### PLANNING COMMISSION MEETING

A. Redevelopment at 9328 Highland Road

Request: Preliminary Site Plan Approval

RE: 9328 Highland Road- Commercial Building with Drive Thru- Preliminary Site Plan Review - 1st

LANDSCAPING PLAN

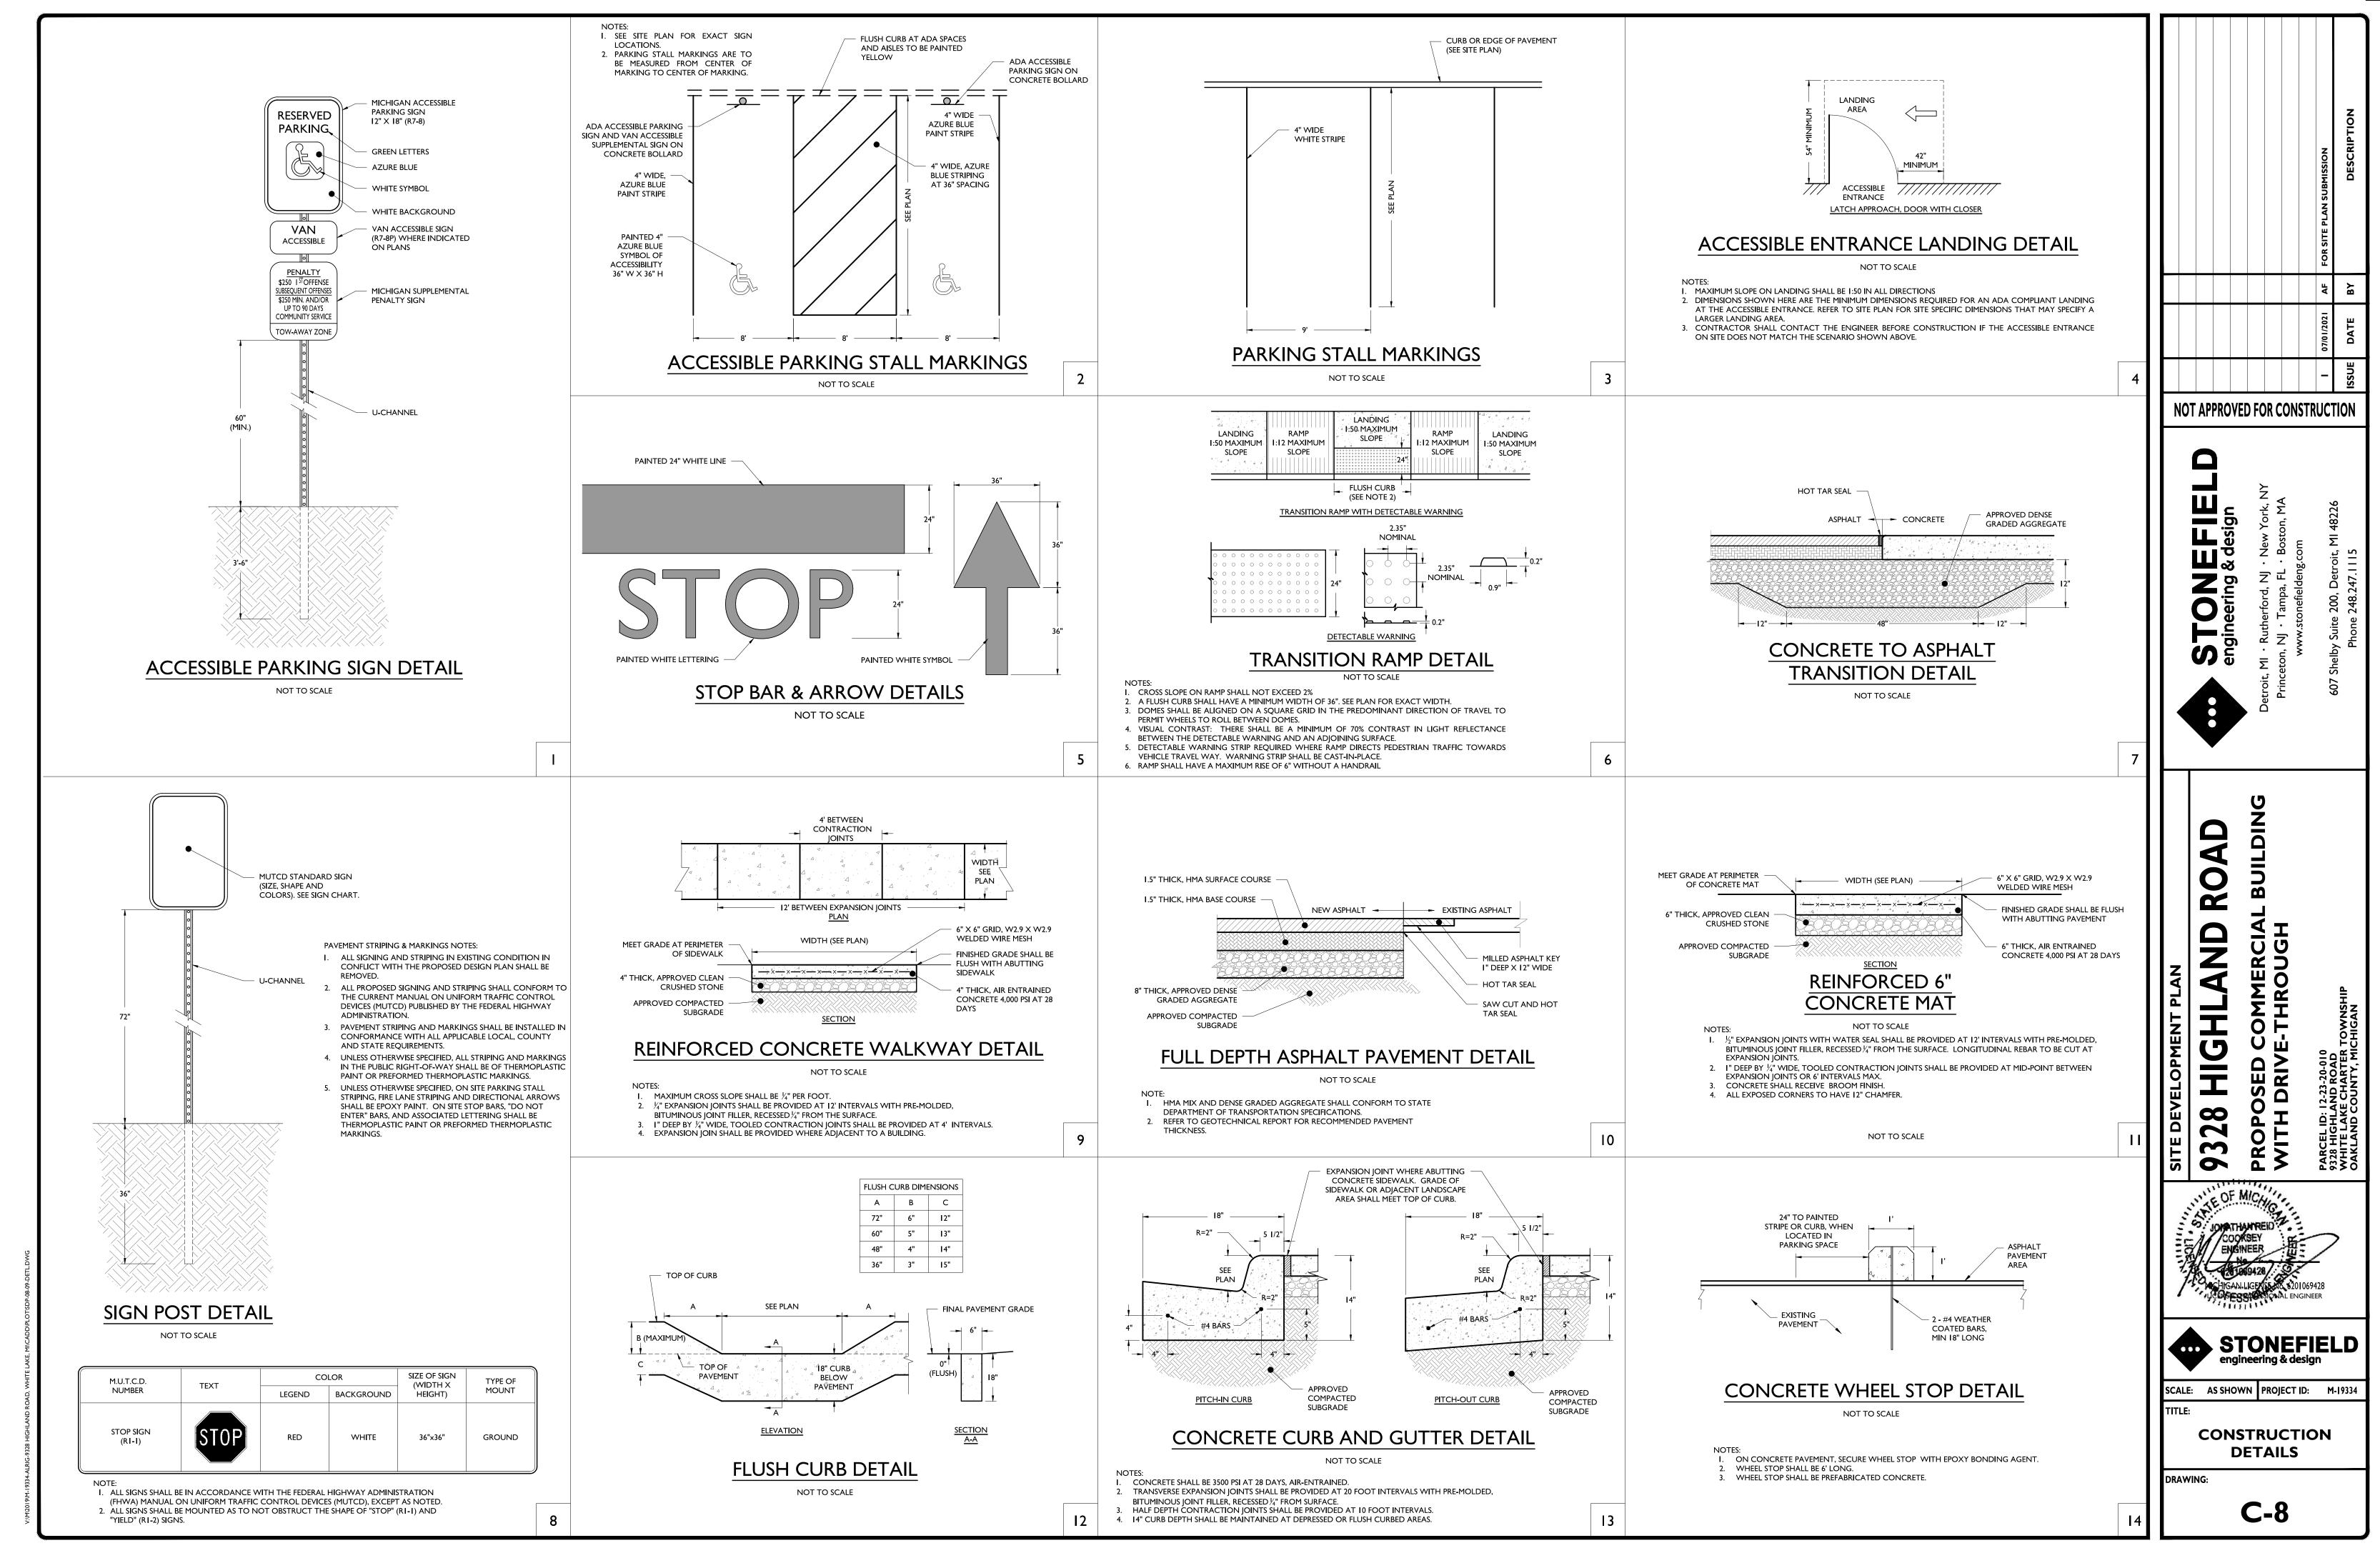
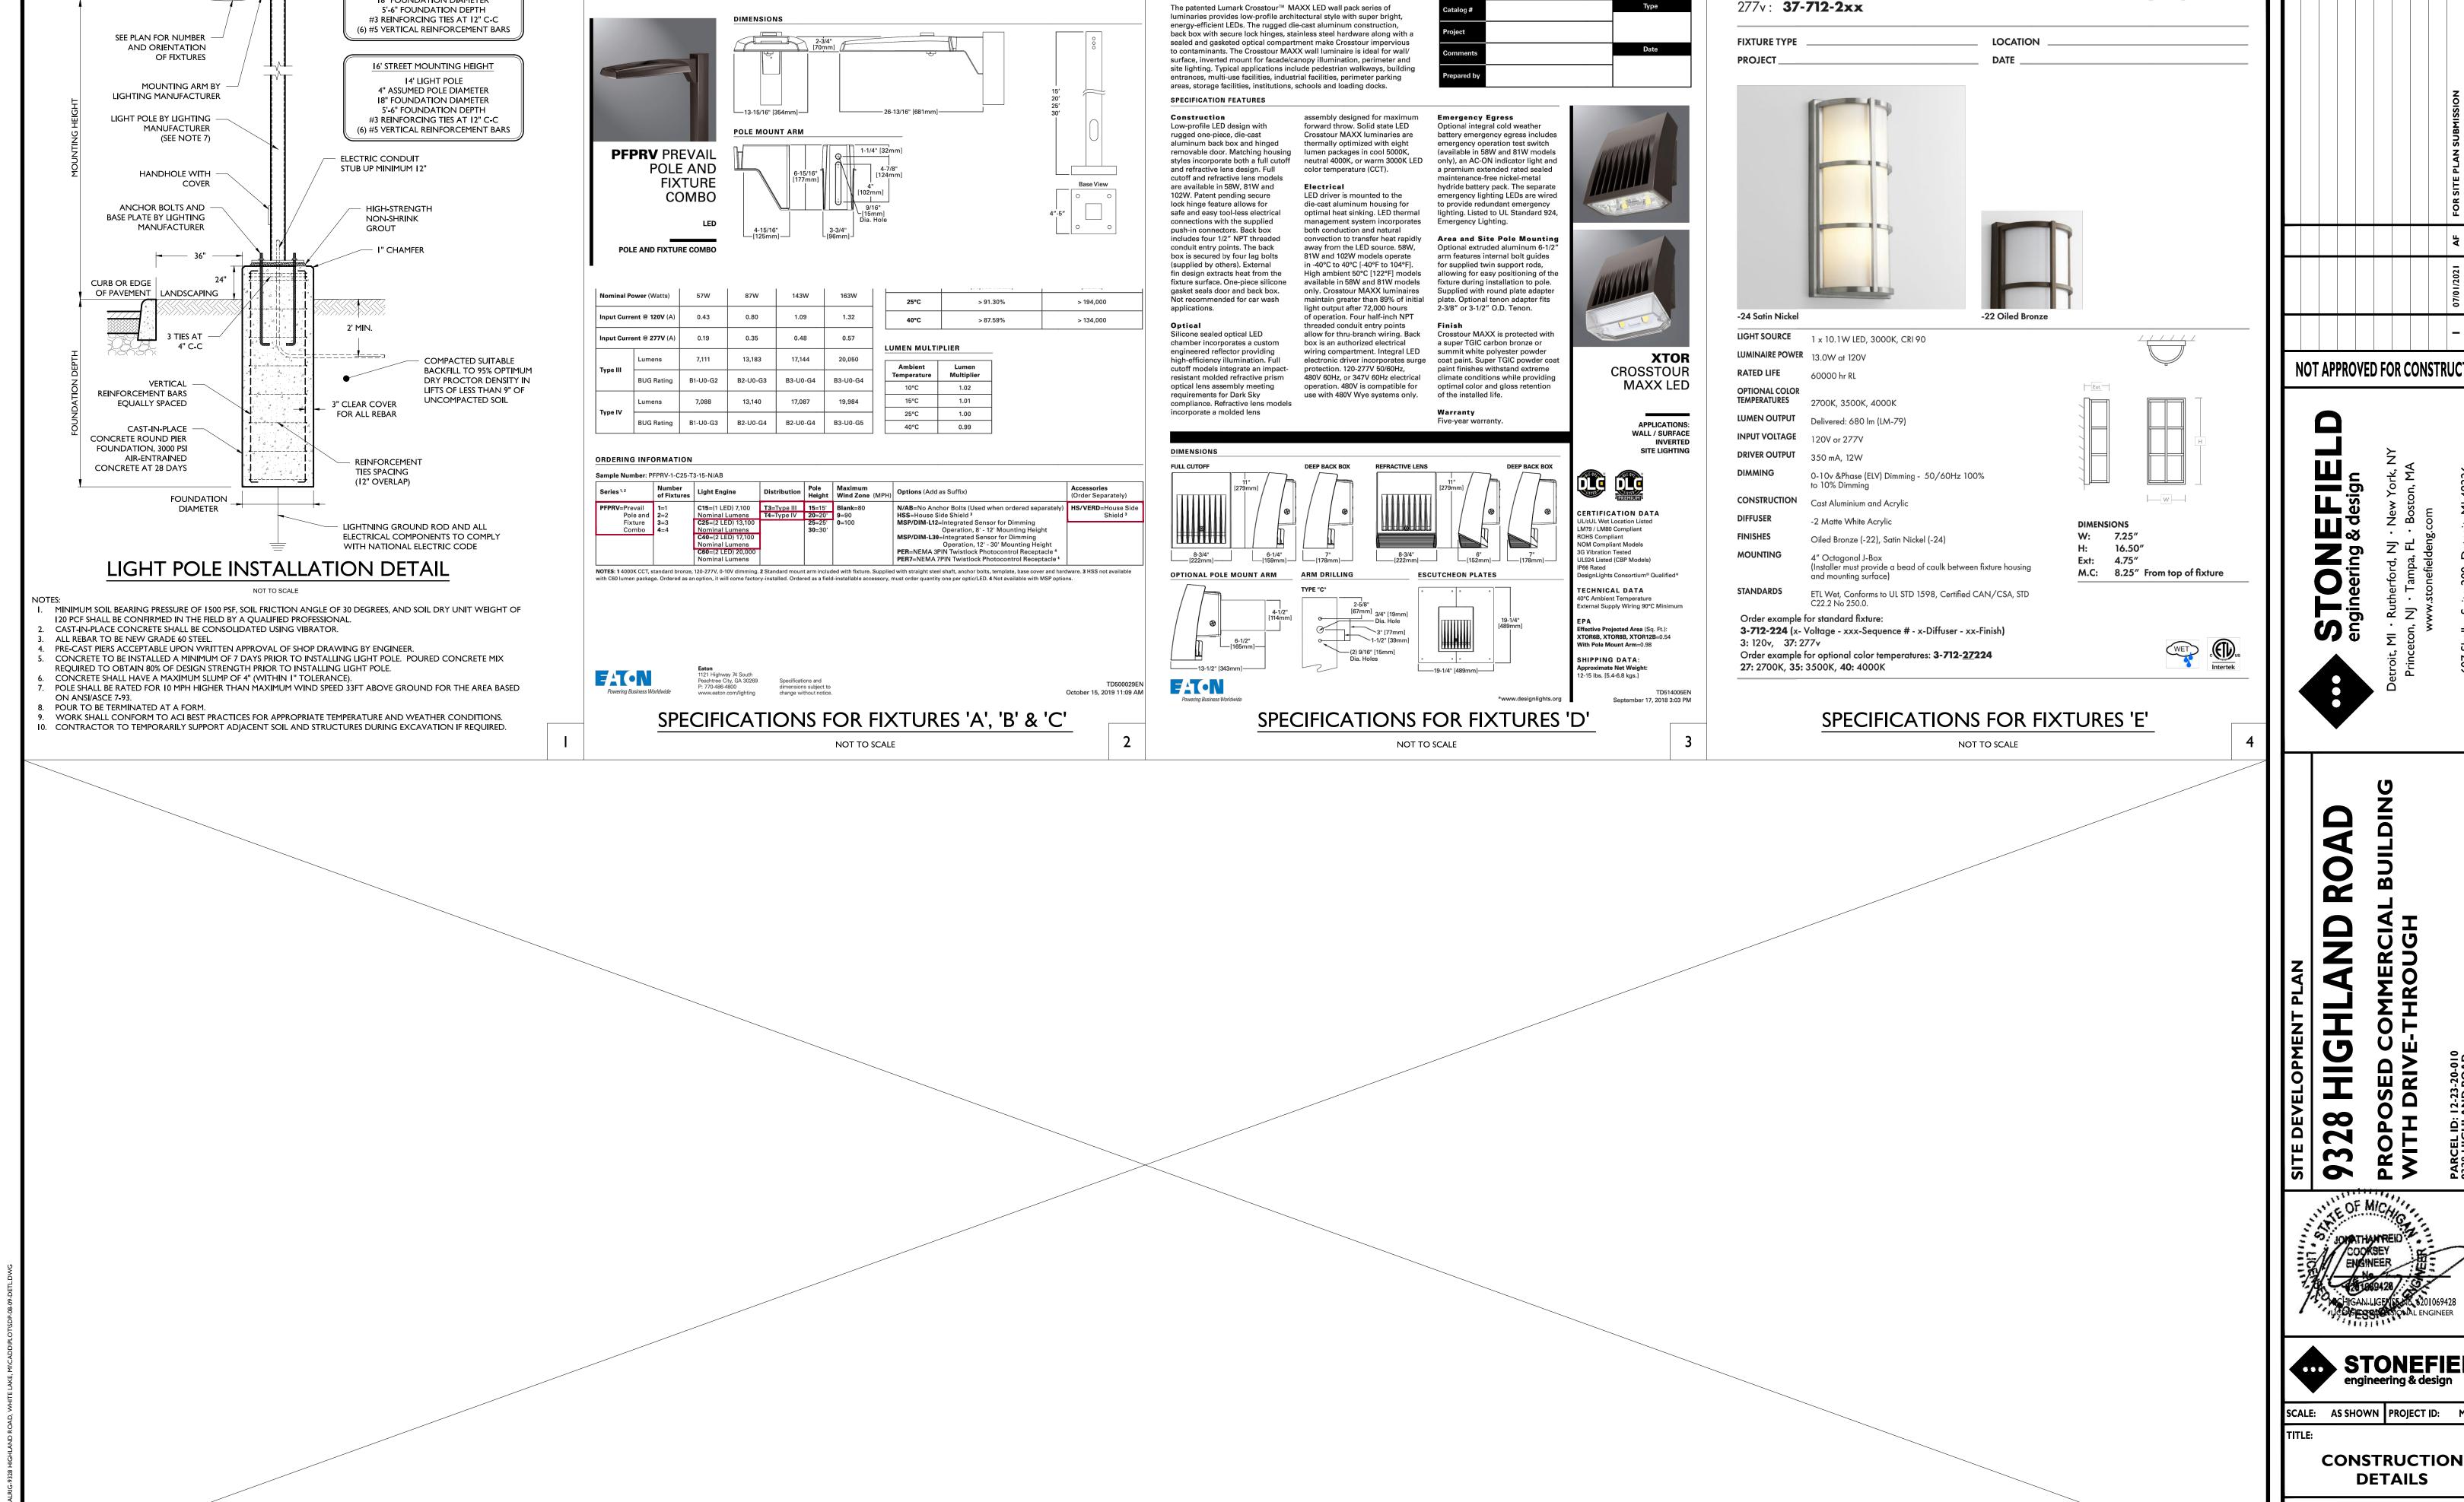
A greenbelt is required on the west and east side lot lines. A four-foot-wide landscaped area (with boxwood shrubs) is proposed on the east lot line. No buffer is proposed on the west, although there is an existing shrub buffer on the Discount Tire site at this shared property line. Again, the applicant's plan states that this is an existing nonconformity. **The Planning Commission should determine if this is appropriate and give direction to the applicant.** Typically, landscape plans are not required at preliminary site plan review, therefore, any direction should be incorporated into the final site plan review landscape plan.

Three notes should be added to the landscape plan:

- A note guaranteeing a two-year guarantee and bond for such for all new plant materials; and
- A note that all landscaped areas that abut parking areas will be separated with a 6-inch curb; and
